Project Name	Coastal GasLink Pipeline Project	Inspection Status	Final
EA Certificate #	#E14-03	Inspection No.	IR2020-055
Project Status	Certified	Inspection Start	2020-10-19
Sector	Energy	UTM	10U 533697 E 6071620 N
Trigger	Planned Inspection	Inspection Type	Field
Project Description	The Coastal GasLink Pipeline Project (Project) is an approximately 650 kilometer (km) long natural gas pipeline connecting facilities in northeast British Columbia (BC) to the LNG Canada facility near Kitimat.		
Location Description	The Project is near Groundbirch (40 km west of Dawson Creek) in northeast BC to the LNG Canada facility near Kitimat. This inspection focused on work being carried out in Sections 1 through 5 of the Project.		
Inspection Summary	<p>From October 19 to 23, 2020 Environmental Assessment Office (EAO) Director of Compliance and Enforcement Chris Parks and Compliance and Enforcement Officer Clayton Smith (collectively EAO C&E) inspected the Coastal GasLink Pipeline Project (Project) against requirements of the Environmental Assessment Certificate (EAC) #E14-03 (Appendix 1). On November 2, 2020 EAO C&E conducted a follow up inspection in Section 4 of the Project near KP 244, north

Photo 7: Wetland ID 040, failing sediment fence.

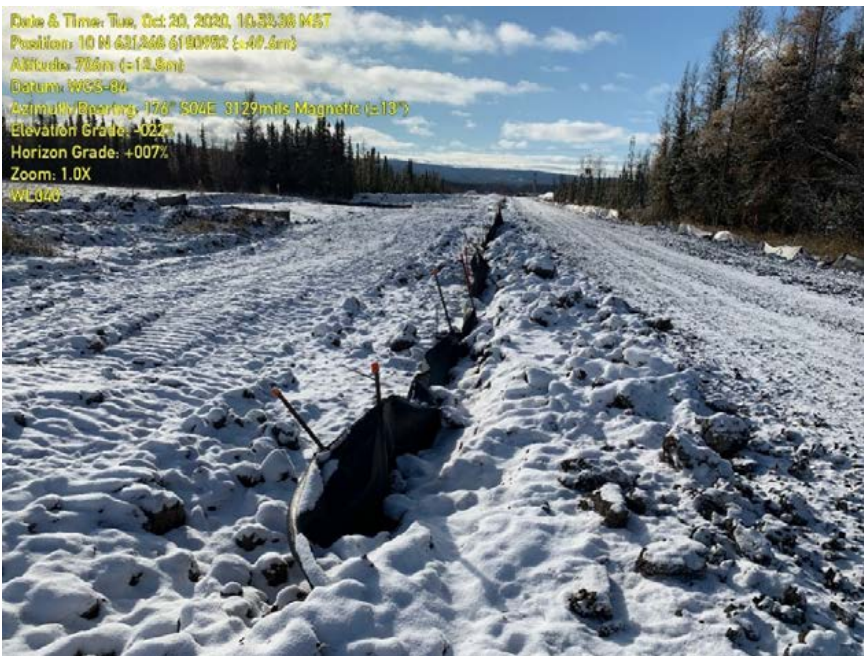
- KP_5+034_CPESC_Site-Specific ESC Plan_Rev1. Commitments in the site-specific plan to install straw wattles, repair failing sediment fencing and remove accumulated material from the fence do not appear to have been followed through. See photo 7 below;

Photo 17: Wetland ID 040, failing sediment fence.

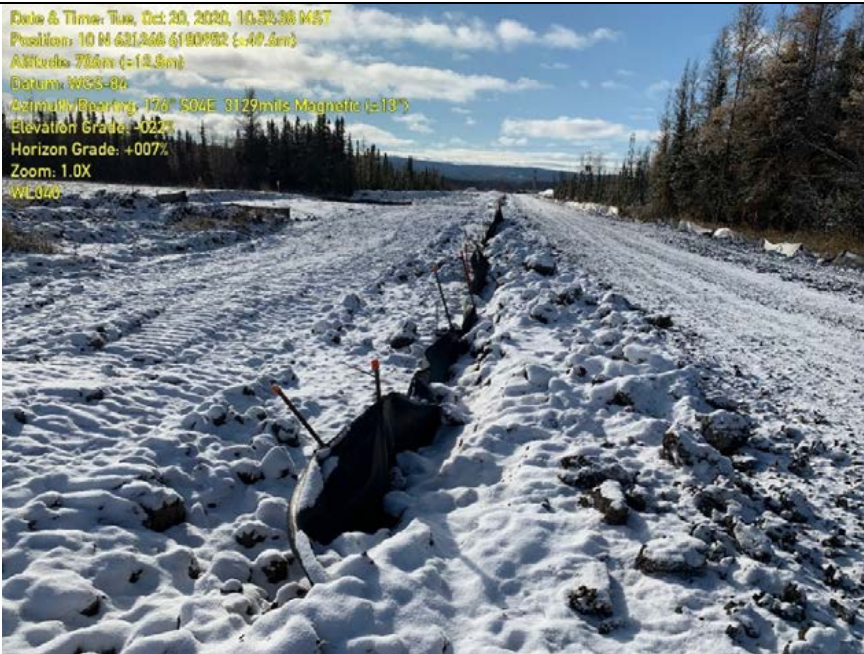
- Sediment fencing installed across riparian features or drainage channel (Photos 14 & 15);
- Failing and/or not maintained sediment fencing (Photos 16 and 17);
- Sediment fence installed in a way that allows water to escape around the edge, in some cases potentially causing erosion and sediment transport (Photo 18);
- Sediment fencing installed in locations not supported by the BMPs (Photos 19 and 20); and,
- Discontinuous sediment fence which allowed for potential sediment mobilization towards watercourses (Photo 21).

Photo 28: Gap beneath sediment fence at watercourse crossing, making ESC measure ineffective.

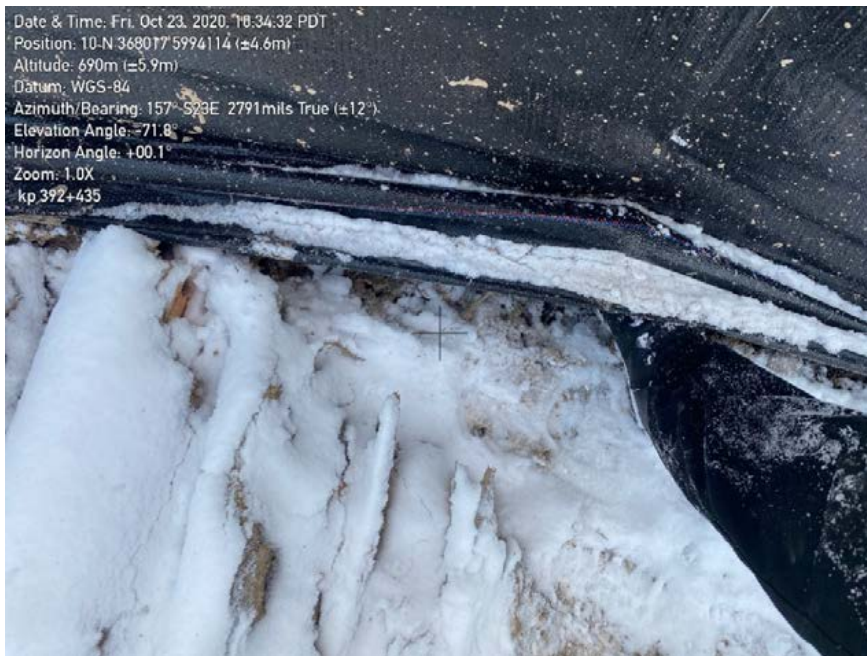
During inspection of Section 5 of the Project, EAO C&E observed deficiencies regarding the installation, appropriate use and maintenance of sediment fencing.

Photo 54: Incorrect installation of straw bails at Crooked River DPI. Not intended to be used within a channel at inlet or outlet of culvert.

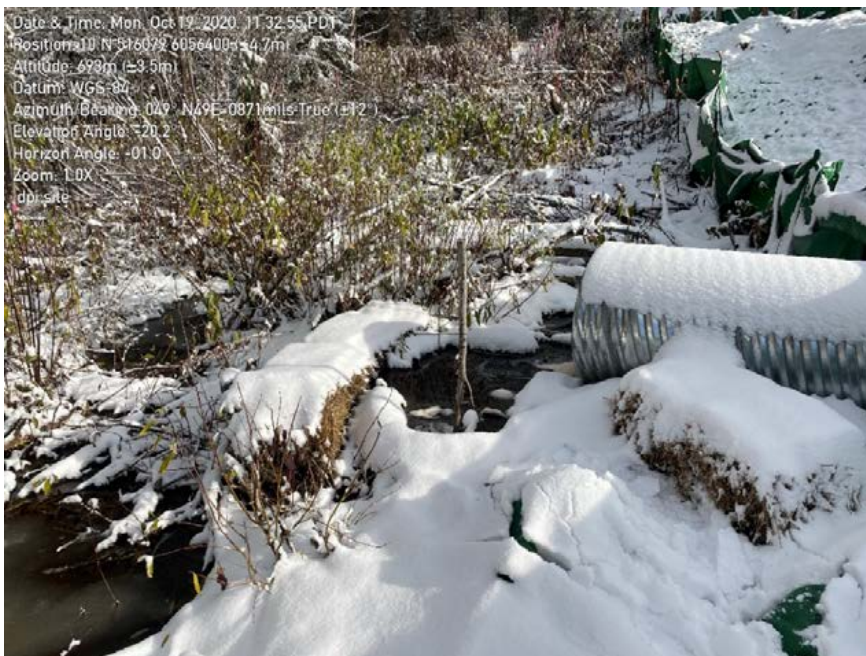
The above observations are examples of erosion and sediment control measures not installed as per the requirements in the Environmental Management Plan, Appendix B - Typical Drawings, specifically drawings STDS-03-ML-05-137.

Photo 62: Geotextile containing sediment; sagging within the channel of S6 watercourse.

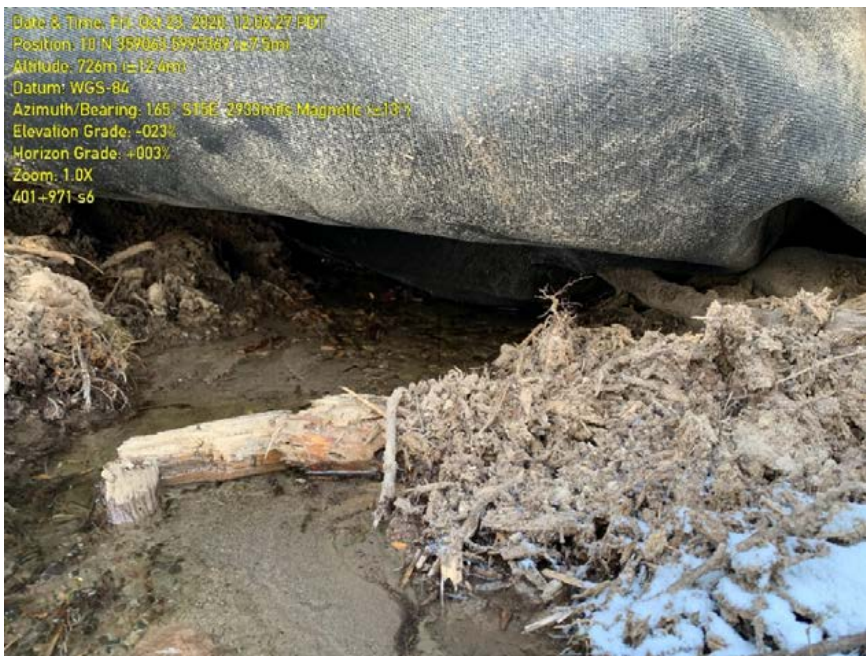
Having the geotextile from the bridges sagging and reaching the watercourse has the potential to introduce deleterious substances into the watercourse, as observed at KP401+971, and may impact stream flows. The observations above provide evidence that installation of geotextile at the three above noted watercourse crossings have not contained material to the bridge deck, have not directed stormwater from the bridge deck away from the watercourse and have not been repaired when warranted.
